HISTORIC AND DESIGN REVIEW COMMISSION

October 21, 2015

HDRC CASE NO: 2015-273
ADDRESS: 151 GRAMERCY PL E
LEGAL DESCRIPTION: NCB 6382 BLK 2 LOT 42, 43,44 & 45
ZONING: R5 H
CITY COUNCIL DIST.: 1
DISTRICT: Monte Vista Historic District
APPLICANT: Timothy Turner
OWNER: Timothy Turner, Elizabeth Turner
TYPE OF WORK: Conceptual approval of front yard fence, roof modification, gutter installation, and rear landing / ADA ramp

Proposed Site Plan
- 317 -

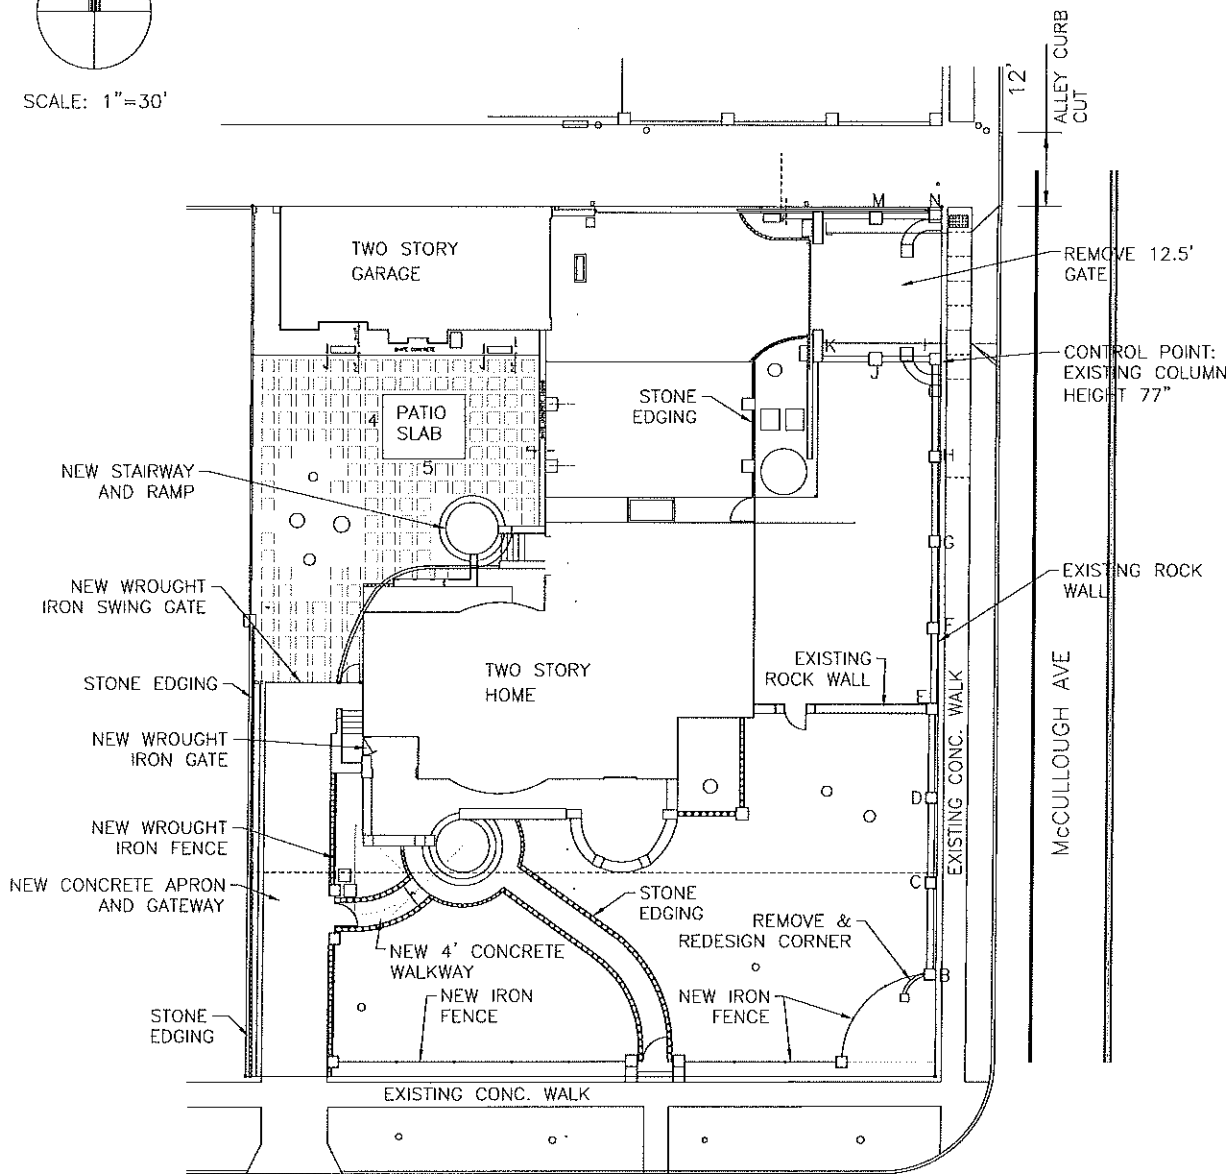
- c) The Guidelines for Site Elements recommend avoiding installing fences in a location where one did not historically exist, particularly within the front yard. The appropriateness of a front yard fence is dependent on conditions within a specific historic district. Throughout the Monte Vista Historic District, most residential properties do not have front yard fences. Sloping, open lawns are the typical way properties in this district meet the street. Two houses on this block of Gramercy (106 and 135 W Gramercy) feature low, ornamental fences in the front yards. However, these properties are not within close enough proximity to 151 E Gramercy to warrant a similar installation. In addition, according to Section 35-514 of the Unified Development Code the maximum allowable fence height on a front yard is 4ft. The proposed fence will exceed the UDC allowable height, and if approved by the HDRC, its construction may require a variance.

1. Staff does not recommend approval of a front yard fence based on finding c.
- 2-3. Staff recommends approval of the roof modifications and gutters based on finding d.
4. Staff recommends approval as submitted based on finding e.

CROSS SECTION OF RIDGE C – East Elevation

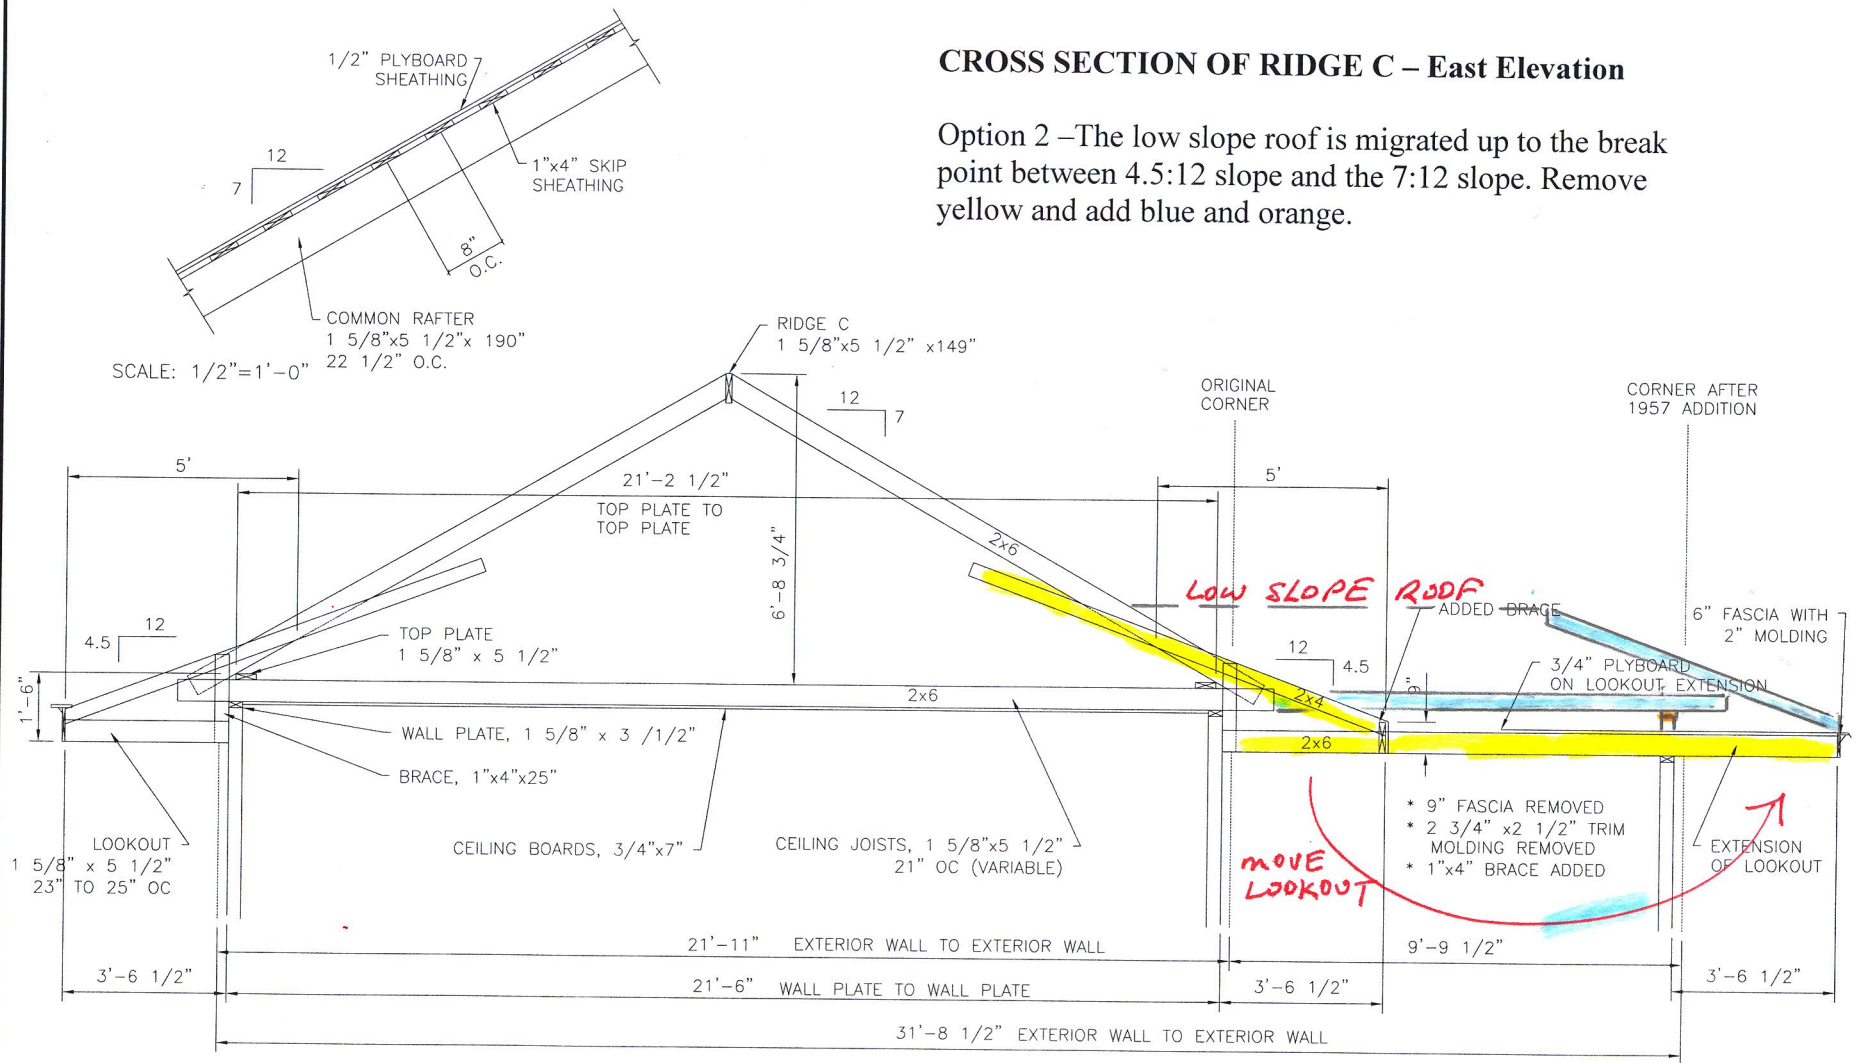
- d) The applicant wishes to alter the existing roof form in order to remove a flat-roof condition at an addition to the northeast corner which is prone to water infiltration and to resolve a condition which prevents the installation of gutters on the house. Consistent with the Guidelines for Exterior Maintenance and Alterations, the original shape, line, pitch, and overhang of historic roofs should be preserved when replacement is necessary. Alteration of the roof on the 1957 addition is appropriate and consistent with the guidelines. Staff finds that the proposed alterations will minimally impact the original roof line and will not be easily viewed from the street. The gutters can be installed with no permanent impact to the fascia and will not obscure any architectural details.

Option 2 –The low slope roof is migrated up to the break point between 4.5:12 slope and the 7:12 slope. Remove yellow and add blue and orange.

Proposed North Ramp
 Site Plan
- 330 -

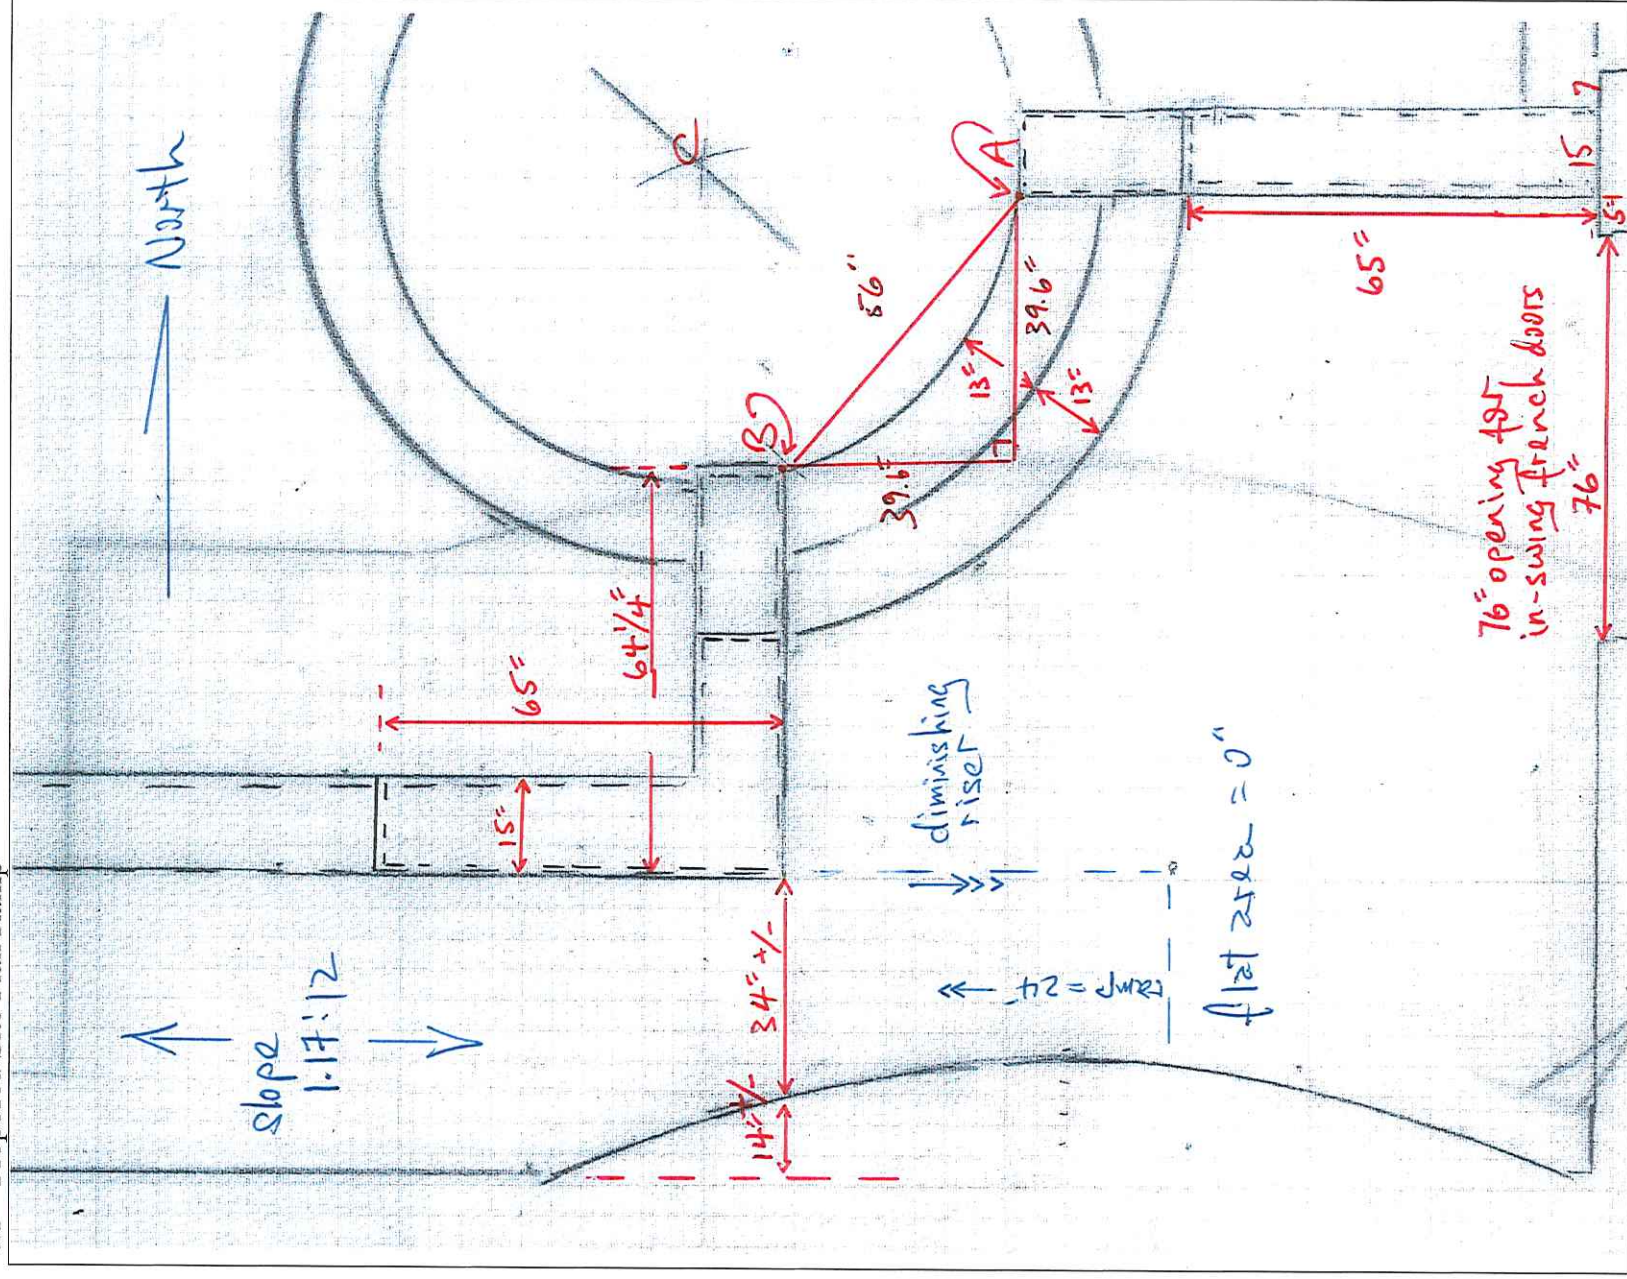
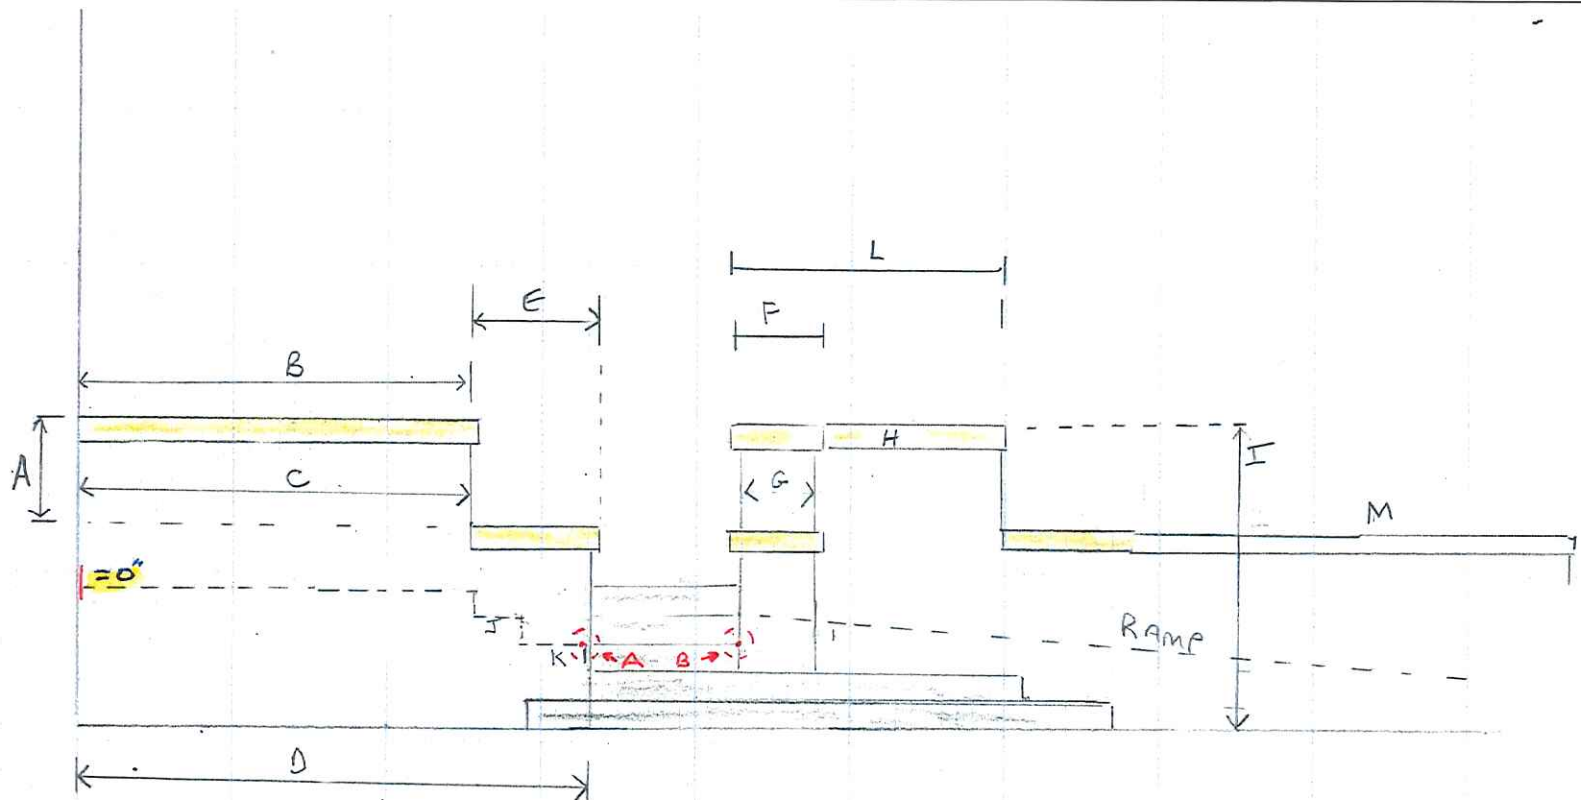
- e) According to the Guidelines for Site Elements, damage to the historic character and materials and modifications to existing door openings should be minimized when compliance with accessibility requirements is necessary. In addition, new ramps should be located at the side or rear of the building, designed to complement the historic character of the building, be visually unobtrusive to minimize visual impact, and be screened from view. The proposed modifications to the rear kitchen door landing and entrance are consistent with the guidelines in terms of their location. Similar proposals are often found to be appropriate when they do not impact a primary façade. The existing stone knee wall which defines the northern side of the landing will be maintained in place, while the remainder will be removed to accommodate the expanded landing and ramp. While alterations to the original landing and stairs are necessary in order to execute the proposed changes, the overall proposal does not impact a primary façade and the proposed landing and ramp can be removed with little impact to the exterior walls.
